Model: T-G1	Date: 5-Jun-06	No.: RJ007001b
-------------	----------------	----------------

Subject: Firmware Release History		Prepared by: Hiromoto Saitoh	
From: 1st Tech. Support Sec. Service Support Dept.			
Classification:	<input type="checkbox"/> Troubleshooting <input type="checkbox"/> Mechanical <input type="checkbox"/> Paper path <input type="checkbox"/> Product Safety	<input type="checkbox"/> Part information <input type="checkbox"/> Electrical <input type="checkbox"/> Transmit/receive <input checked="" type="checkbox"/> Other ()	<input type="checkbox"/> Action required <input type="checkbox"/> Service manual revision <input type="checkbox"/> Retrofit information

Model: T-G1/T-G1N/Pi-G1N		Date: 6-Sep-06	No.: RJ007004
Subject: B-Finder set-up procedure		Prepared by: Hiromoto Saitoh	
From: 1st Tech. Support Sec. Service Support Dept.			
Classification:	<input type="checkbox"/> Troubleshooting <input type="checkbox"/> Mechanical <input type="checkbox"/> Paper path <input type="checkbox"/> Product Safety	<input type="checkbox"/> Part information <input type="checkbox"/> Electrical <input type="checkbox"/> Transmit/receive <input type="checkbox"/> Other ()	<input type="checkbox

- **Change** the area highlighted in red below.
pg.98 Self-Diagnostic Test Flow

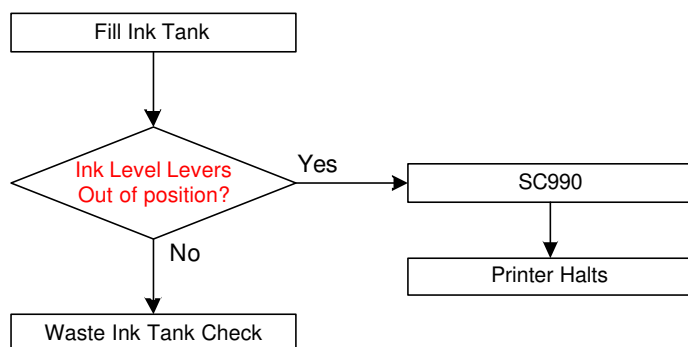
The following changes were made to the Service Manual.

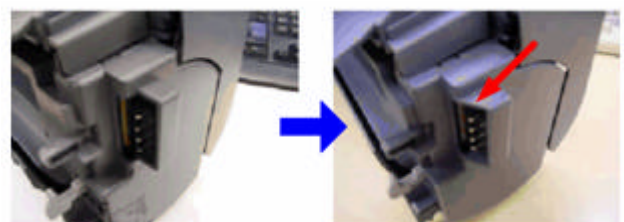
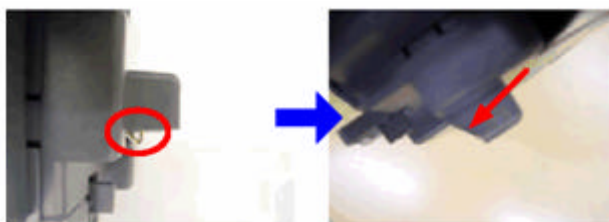
The duplex unit is opened/closed with excessive force many times. As a result, one or more of the terminal pins on the duplex unit connector is bent or damaged.

The connector housing was strengthened (applied from 2006 winter mainframe production).

Step 1 (Applied from: Feb. 2007 production):

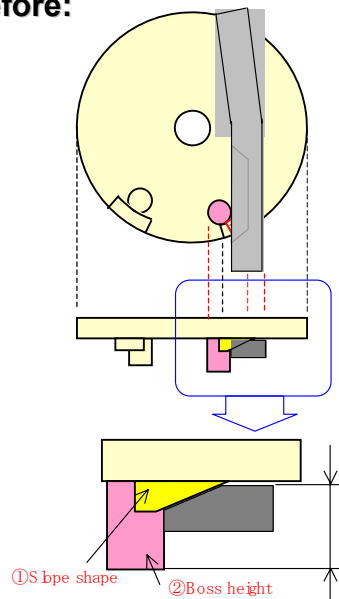
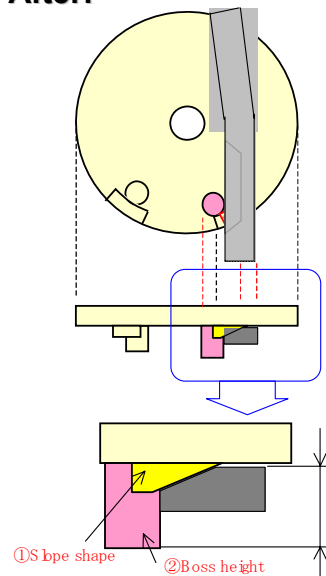
1. The shape of the lever was changed.
2. The height of the pin was changed.
